CitiPower/Powercor Technical Standards Update for September 2020

EB Poles – Concrete Poles - EB001, EB041, EB406, EB606 & EB786

GL041 & GL662 - Kiosk box foundation covers

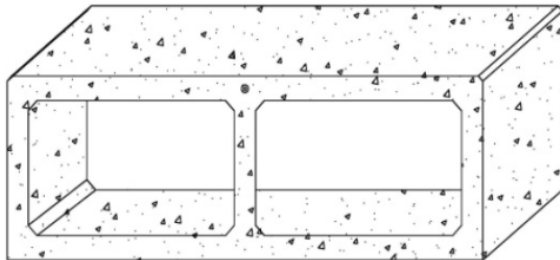
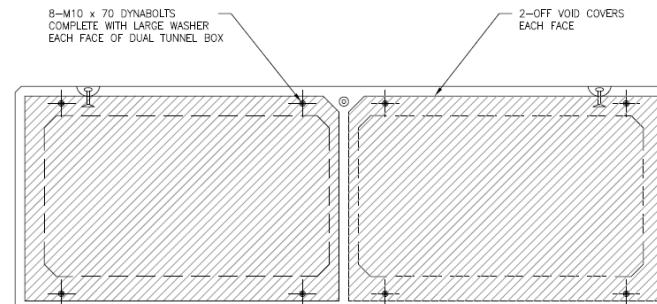
- Technical Standards GL041 & GL662 have been updated to include new hardened PVC covers for the front & rear openings of the kiosk box foundation.
- The box foundation will now be supplied with 4 x grey PVC covers, 840mm(h) X 1290mm(w) X 12mm(t) and M10 x 70mm galvanised steel Ramset-DynaBolts to attach the covers to the foundation.
- Similar to the previous covers, the new PVC covers may be drilled out to enable cables to be run through the box foundation.
- Technical Standard GL041 has also been updated to provide further guidance on the earthing requirements for the foundation.

- Field feedback has advised that some of the existing fibre cement covers have been breaking. Therefore a more durable plastic cover has been developed.
